## REQUEST ANALYSIS AND RECOMMENDATION

#### 06AN0263

# Matoaca Magisterial District Vicinity of 13701 Cedar Creek Road

REQUEST: A Variance to use a parcel of land which has no public road frontage for dwelling purposes in an Agricultural (A) District.

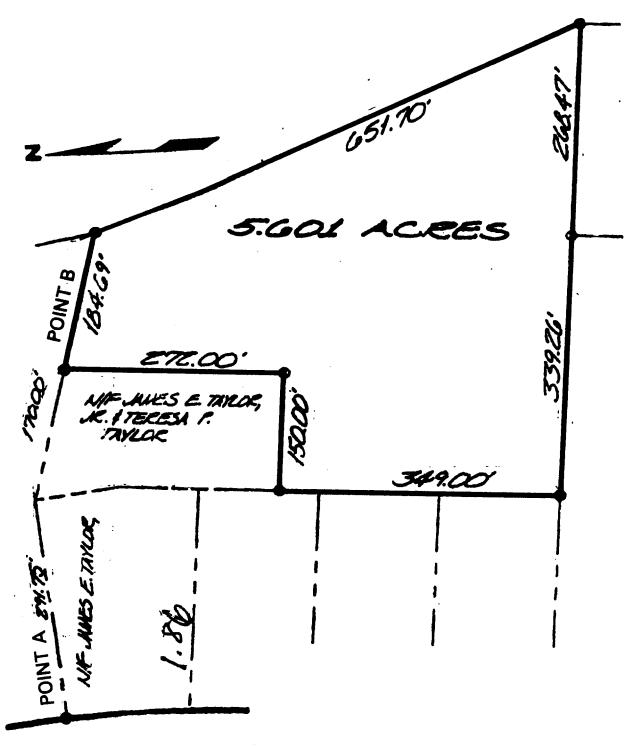
A thirty (30) foot wide private access easement from Point A to Point B as shown on the plat attached to the staff report.

- (b) A fifteen (15) foot wide roadway shall be constructed and maintained to all weather standards from Point A to Point B. Prior to issuing a Certificate of Occupancy, the Planning Department shall inspect this roadway to determine its compliance with the following standards:
